**Ref:** MTO Comments on Traffic Impact Study

Ainley Group received comments on the Traffic Impact Study (Blessington Road Development) from MTO dated October 28, 2020. The following is a response to the MTO comments.

INTERSECTION  
 VEHICLE TRACKING

CONTRACT No. 20525-1 DWG 20525-VT

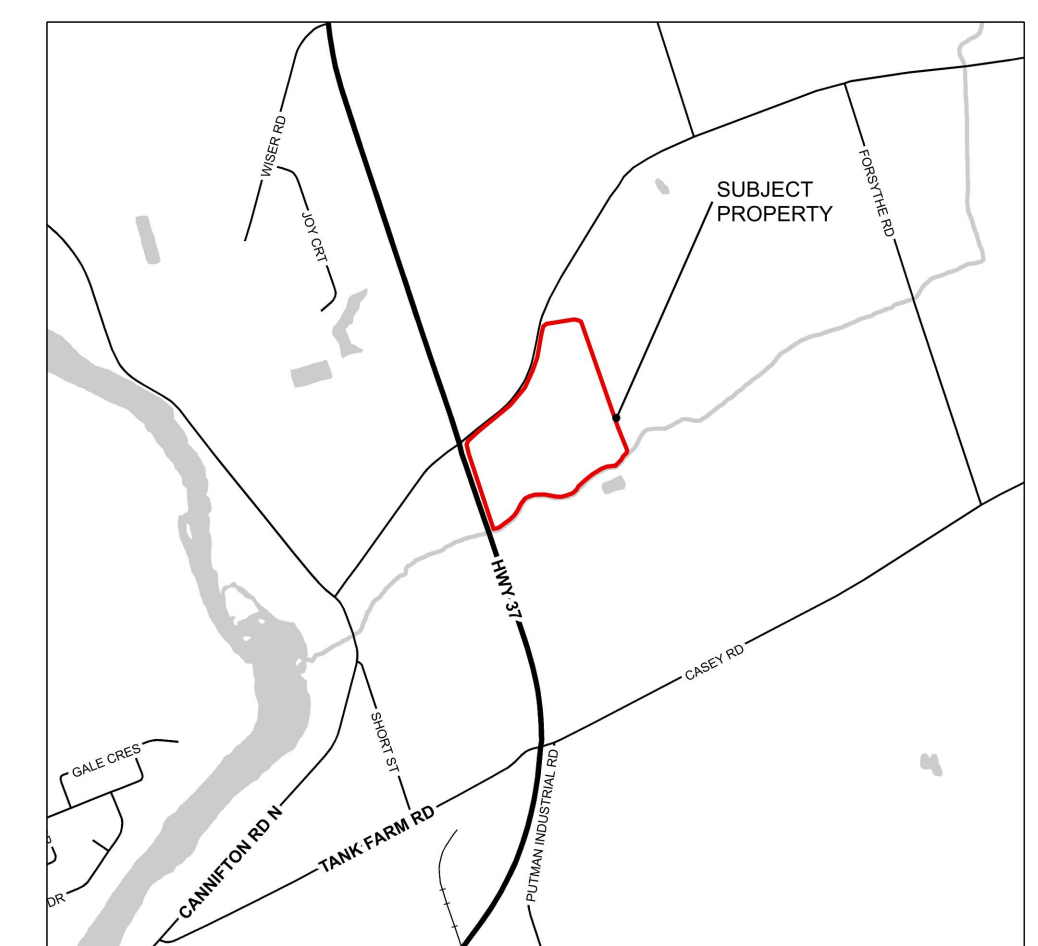
*MTO Comment #2: Review of the geometrics of the Highway 37/Blessington Road Intersection including Auto Turn software analysis for WB-20 design to ensure the trucks for this development can manoeuvre through the intersection without encroaching on other lanes, shoulder or curbing. From a review by MTO, it does not appear that this intersection was designed with WB 20's, as Blessington Road is not an industrial or commercial area receiving trucks. Auto Turn tracking for the WB-20 vehicle for both the southbound and northbound movement onto Blessington Road will need to be included. Is any mitigation required to ensure the intersection geometrics work at this intersection? Are any signals/poles impacted? If so, what improvements are proposed?*

Ainley Response #2: As per the MTO Design Supplement for TAC Geometric Design Guide for Canadian Road – June 2017, a rural arterial links the major regions of a province and should be able to serve all types of vehicles and up to 20% of traffic is heavy trucks. Given that the City has no truck restrictions on Blessington Road, trucks on Highway 37 are allowed to turn to/from Highway 37. In the TAC Geometric Design Guide for Canadian Road Table 2.4.4 for a WB-20 vehicle, the minimum turning radius for a turn of 90 degrees is 10.7 m for outside front wheel (9.6 m for centre of axle). The current northeast quadrant curb radius is 18 m and southeast quadrant curb radius is 24 m (both >10.7 m). Therefore, a WB-20 truck to/from the site can maneuver through the intersection without encroaching on other lanes, shoulder or curbing. The attached figure illustrates the same.

The TIS has included the intersection of Blessington Road/Hwy 37 and found that no improvements (i.e. left turn lane or right turn lane or additional through lane) are required as a result of the increased site traffic (see Executive Summary Key Findings). The report has analyzed the intersection from existing conditions to future background conditions and future total conditions.
